Ford/Mazda Truck Calipers

10-3200S/10-3201S

10-3260S/10-3261S

TT3200/3260

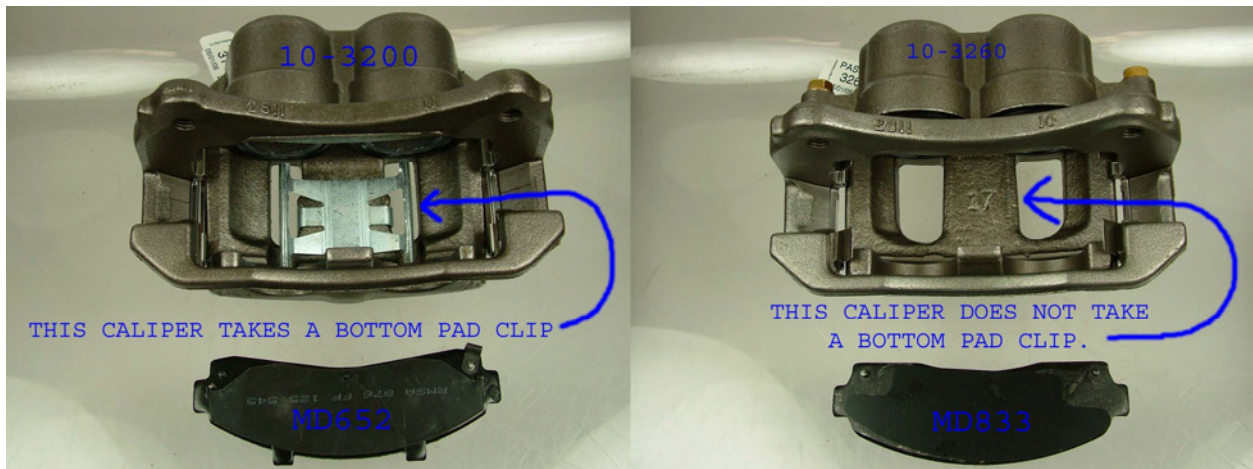
The 10-3200S/10-3201S calipers fit Ford Explorers and Rangers and Mazda B-Series pickups from 1995-2001. In 2002 the vehicles changed to the 10-3260S/10-3261S calipers. ***These calipers are very similar and can be used interchangeably.*** However, the 10-3200S/10-3201S casting allows for a bottom pad clip to be installed and, as a result, uses the 652 pad. The 10-3260S/10-3261S casting does not allow for this pad clip and, as a result, uses the 833 pad.

While the change to this braking system appears to have been made starting with the 2002 models, UCX has found both of these caliper sets on vehicles spanning the 1995 and up range. As noted above, the calipers are interchangeable but the Tech must be aware of the pad/pad clip differences to insure proper installation.
